Betchworth Parish Council's ("The Council") response to The Gatwick Route 4 Redesign of RNAV Standard Instrument Departures Second Design Options Focus Group 21st November 2019.

Route 4 Workshop – November 2019

Airspace Change –Gatwick Airport Route 4 Standard Instrument Departures

Option Four – multiple routing on the turn, similar to pre – 2012 flying with dispersal in the turn, multiple routings, multiple way points. Would impact new areas outside NPR due to noise cone

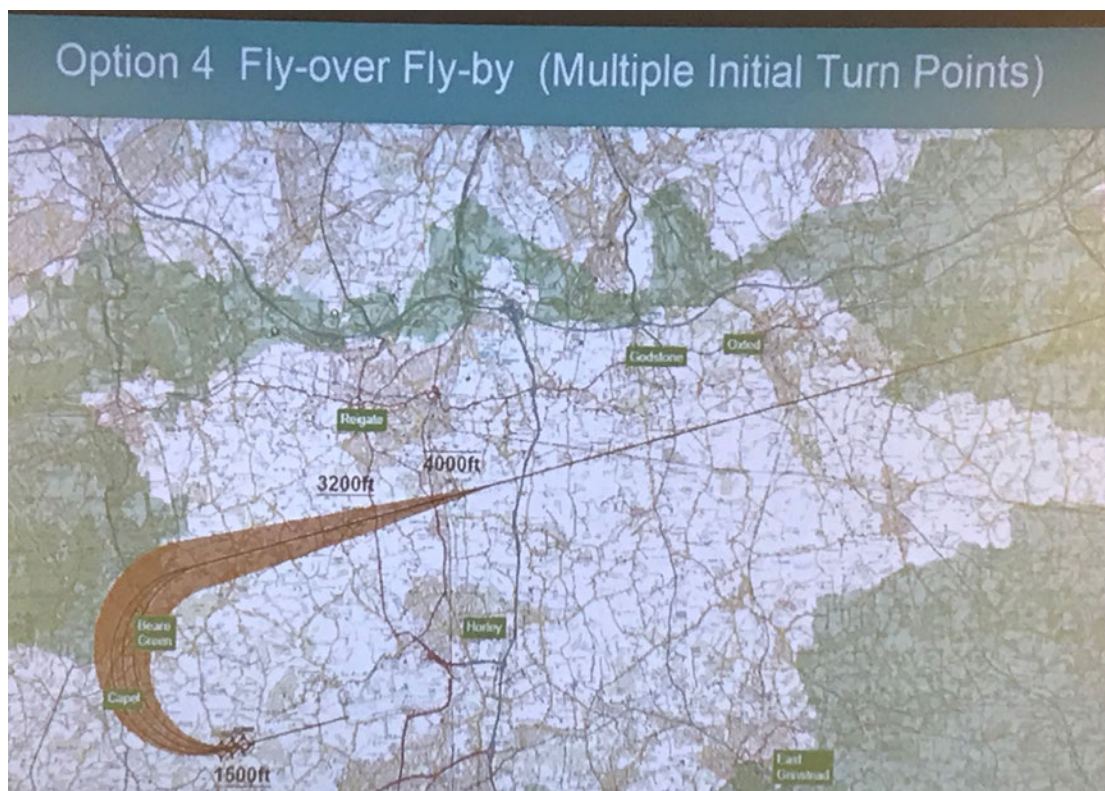
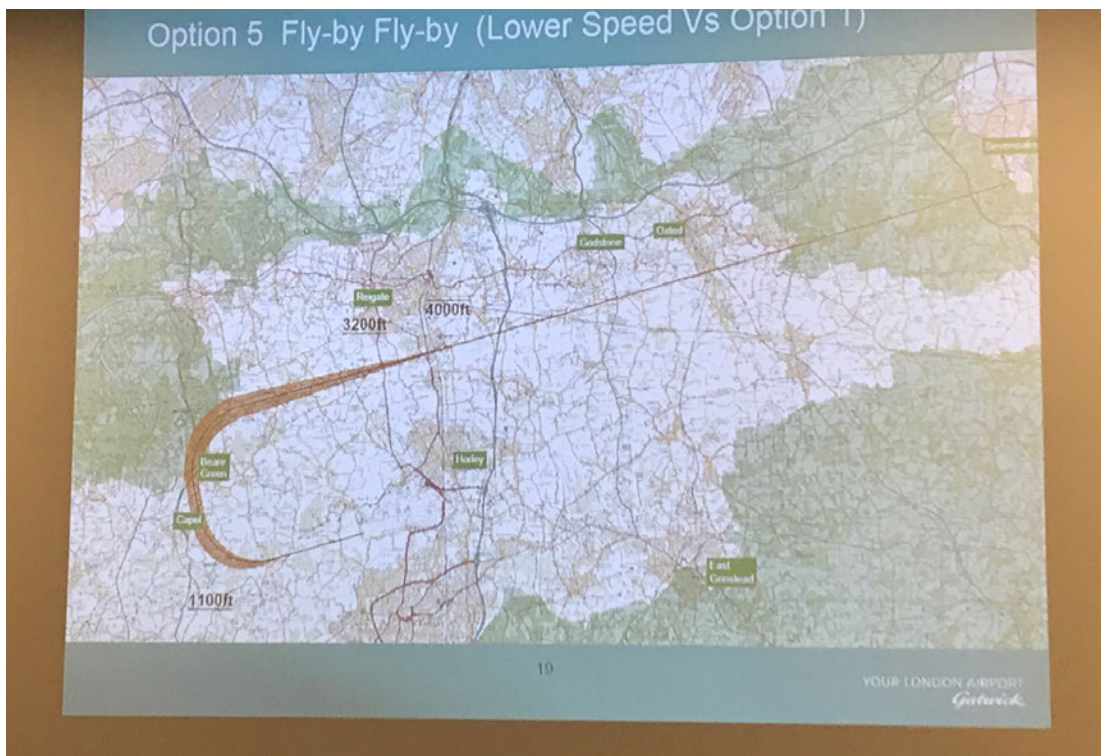
Option Five – More aircraft engine power on departure that would increase noise for those closest to the runway. A tight turn at 190 knots speed creating a lot more noise and making the turn difficult to stay inside the NPR
